**TOWN OF BAY HARBOR ISLANDS
MORRIS N. BROAD COMMUNITY CENTER
1175 95TH STREET
BAY HARBOR ISLANDS, FL 33154**

DESIGN REVIEW BOARD

**June 30, 2026
7:00 PM**

FINAL AGENDA

REVISED EAST ELEVATION

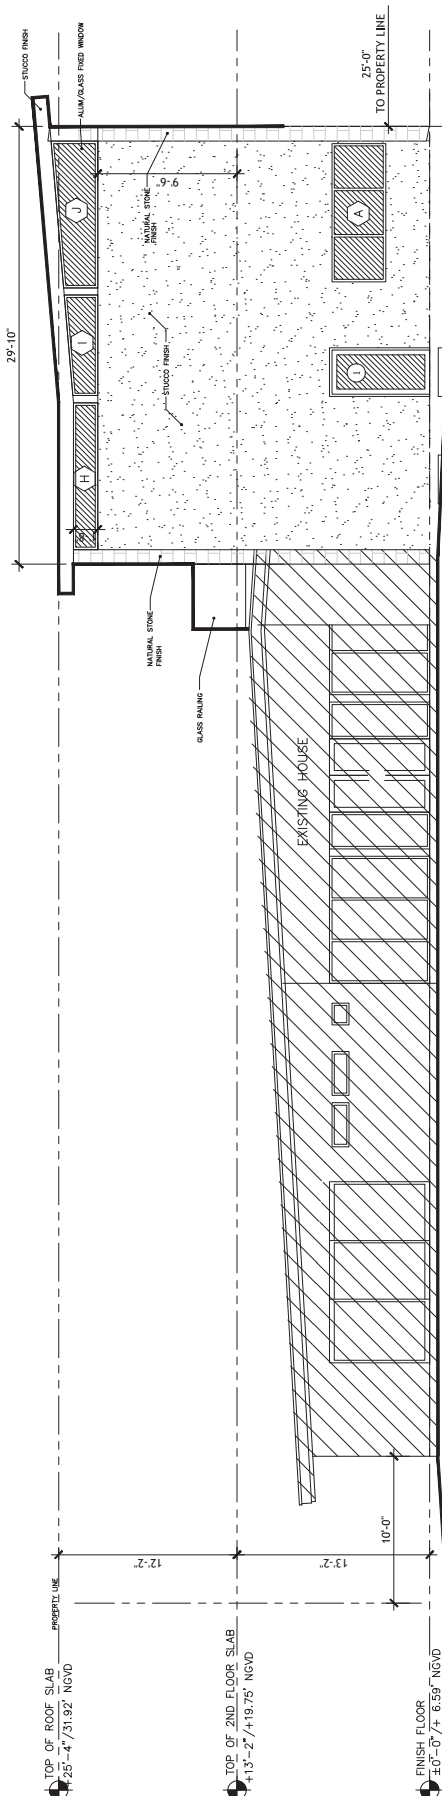
- North Elevation: Addition of a new window above the existing sliding glass doors.
- East Elevation: Addition of a new window within the stairwell.
- Facade Finishes: Evaluation of alternative exterior stone materials and finishes for portions of the facade.
- Front Elevation: Consideration of retaining the current green wall in lieu of the previously approved stone cladding.

1. North Elevation: Addition of a new window above the existing sliding glass doors.
2. East Elevation: Addition of a new window within the stairwell.
3. Facade Finishes: Evaluation of alternative exterior stone materials and finishes.
4. Front Elevation: Consideration of retaining the current green wall in lieu of stone cladding.
